**Larson Architects, P. A.**  
*Architecture and Real Estate Planning*  
**210 Murray Street, Boise, Idaho 83714**  
**Phone: (208) 376-7502 Fax: (208) 658-0224**

**RE: 4379 W. Chinden Blvd.- Advance Auto Parts Summary Letter**

**PROJECT NAME**  
 A NEW WAREHOUSE FOR  
 ADVANCE AUTO PARTS  
 4379 W. CHINDEN BLVD.  
 GARDEN CITY, IDAHO 83714

**FLOOR PLAN**

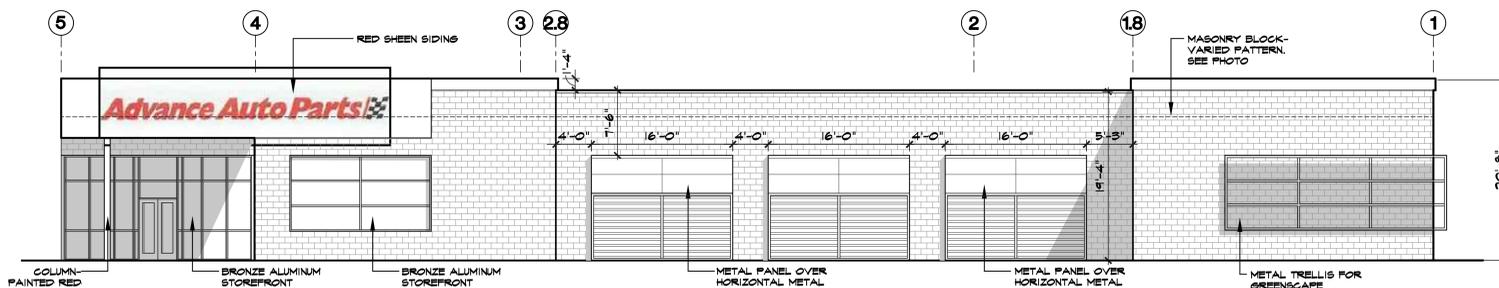
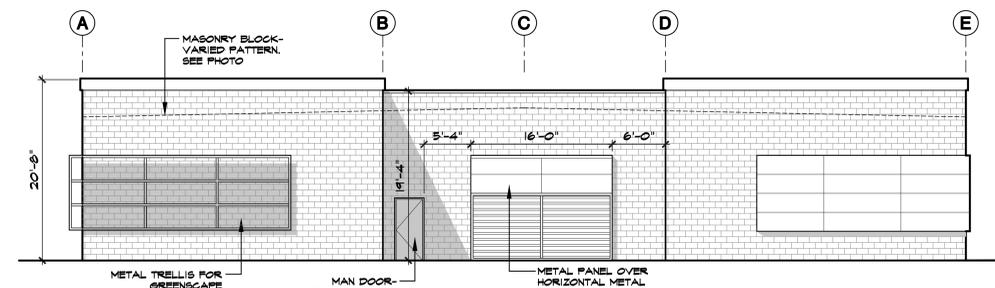
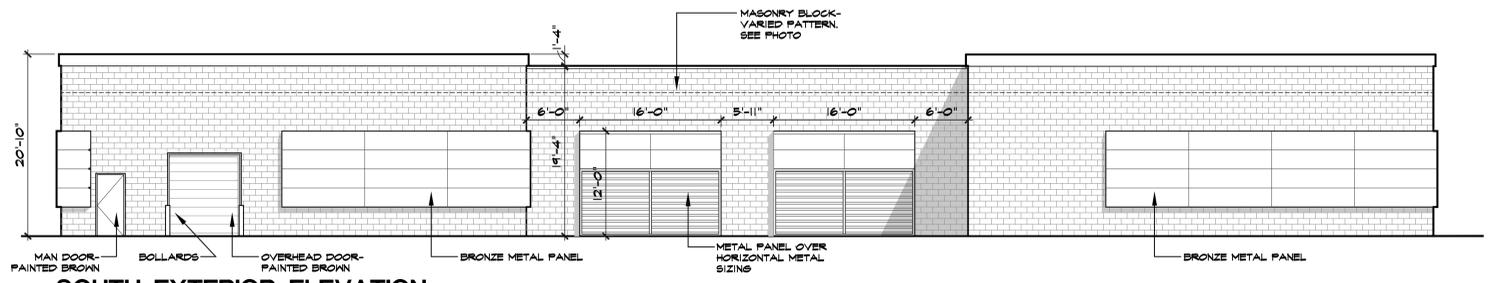
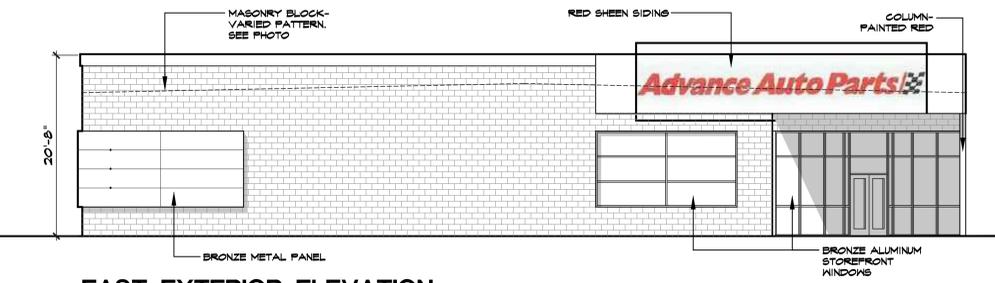
É No blank walls facing Chinden or 44th: Add windows, architectural features, material changes, etc. to add interest and incorporate human scale elements to the building.

É Greater than 50% of the façade requires windows for a retail use.

É Demonstrate compliance with 8-4C-3 A. Objective #1. The design of all structures shall have a scale, massing and urban form that has a relationship to the street, the pedestrian, and adjacent properties.  
6. Wall Plane: Facades should have no wall plane wider than two and one-half times the height of the wall plane. If a new wall plane is required to achieve compliance with this requirement, it must be offset by at least six feet (6ø).

É To add interest to blank walls, consider art as an option.

***Response: A steel trellis is now shown on the corner of 44<sup>th</sup> and Chinden. Each building recess now shows a combination of metal panel and siding elements to provide visual interest. Metal panels were added to the southwest and southeast corners of the building.***

***Response: Advance Auto will be utilizing all perimeter walls for full height merchandising or parts storage. We request that the proposed features mentioned above will be an acceptable alternative to windows.***

***Response: Wall plane offsets have been increased to 6'-0".***

***Response: Per proposed elevations, no blank walls are provided.***

**LANDSCAPE PLAN**

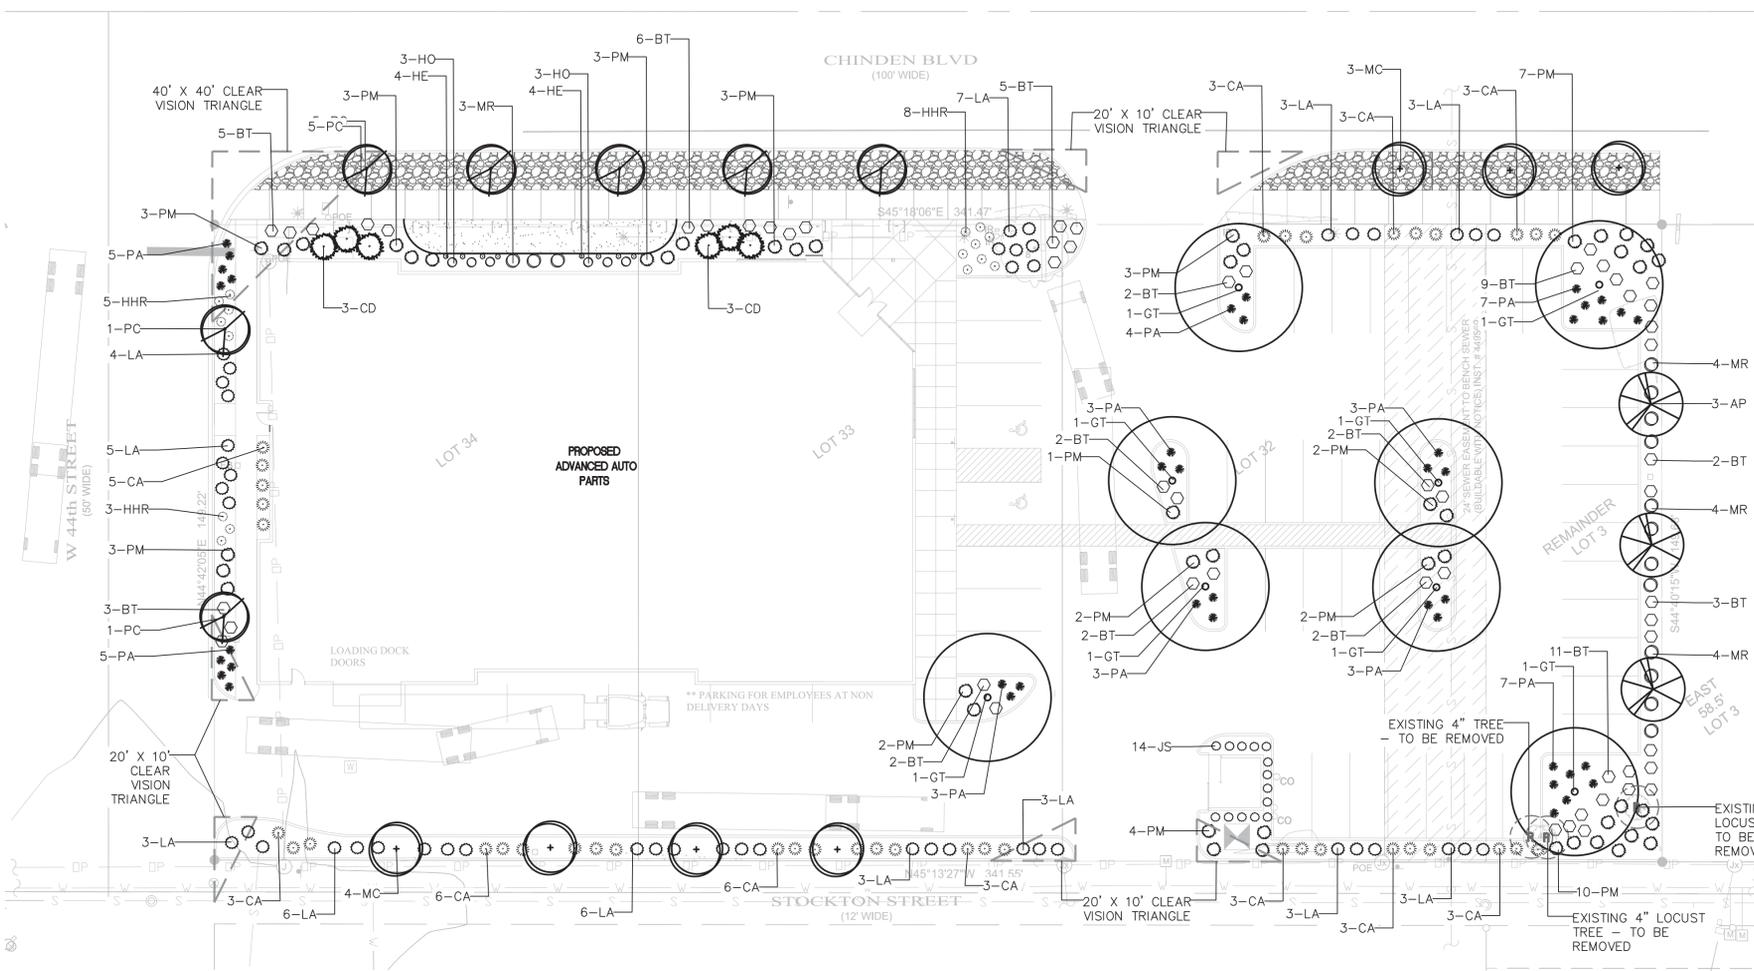
É Detached five foot sidewalk along 44th Street is required by code and to create pedestrian connectivity for the property to the south and circulation around the block itself.

É Consider adding variation to the tree species on each street side

***Response: A 5'-0" sidewalk is now shown on the site plan and landscape plan.***

***Response: Please see revised landscape plan showing more variation in tree species.***
